Access Compliance Report

Public Rights-of-Way

Intersection ID: 13595	Main Street: DEWBERRY_TR	Cross Street: DR_CARVER_RD	Location: SE
ADA ID: 5316DDBA1333	Ramp Type: Perp	Initial Pass/Fail: Fail	Overall Compliance: No
Severity Score: 8.75			
Codes/Mitigation Info/Possible Solution		Field Measurements/Component Compliance

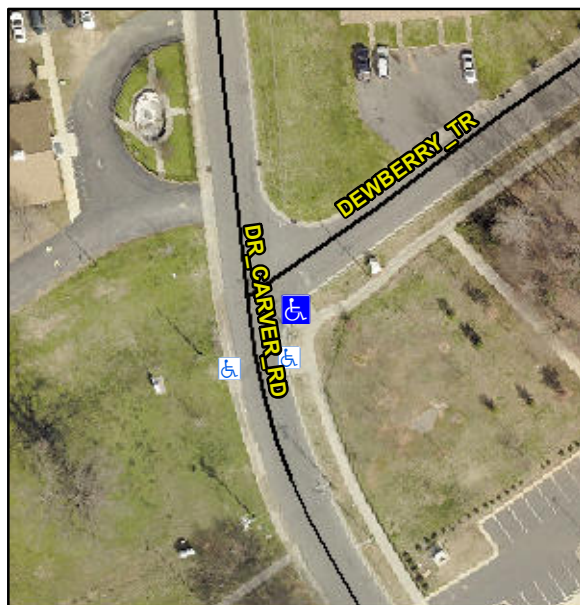
Not Found, R304.5.1

Compliance	Description	Data	Compliance	Description	Data
N/A	Ramp Length (in)	96.0	Yes	Ramp Slope (%)	6.2
No	Ramp Width (in)	47.0	Yes	Ramp XSlope (%)	0.7
N/A	Flare Type LT	N/A	N/A	Flare Type RT	N/A
N/A	Flare Slope LT (%)	N/A	N/A	Flare Slope RT (%)	N/A
N/A	Flare Traversable LT?	N/A	N/A	Flare Traversable RT?	N/A
N/A	Landing Length (in)	N/A	N/A	DWS Provided?	N/A
N/A	Landing Width (in)	N/A	N/A	DWS Contrast?	N/A
N/A	Landing Slope (%)	N/A	N/A	DWS Length (in)	N/A
N/A	Landing X Slope (%)	N/A	N/A	DWS Full Width?	N/A
N/A	Landing Curb? (Y/N)	N/A	N/A	DWS Offset (in)	N/A
N/A	Shared Landing?	N/A			
N/A	Gutter Ponding?	N/A	N/A	Gutter Slope (%)	N/A
N/A	Gutter Lip Ht (in)	N/A	N/A	Gutter X Slope (%)	N/A
N/A	Painted X Walk1?	No	N/A	Painted X Walk2?	N/A
	X Walk 1 Direction	To N		X Walk 2 Direction	N/A
N/A	X Walk 1 Width (in)	N/A	N/A	X Walk 2 Width (in)	N/A
	X Walk 1 Slope (%)	5.3		X Walk 2 Slope (%)	N/A
	X Walk 1 X Slope (%)	1.9		X Walk 2 X Slope (%)	N/A

Remove & Replace Entire Ramp.
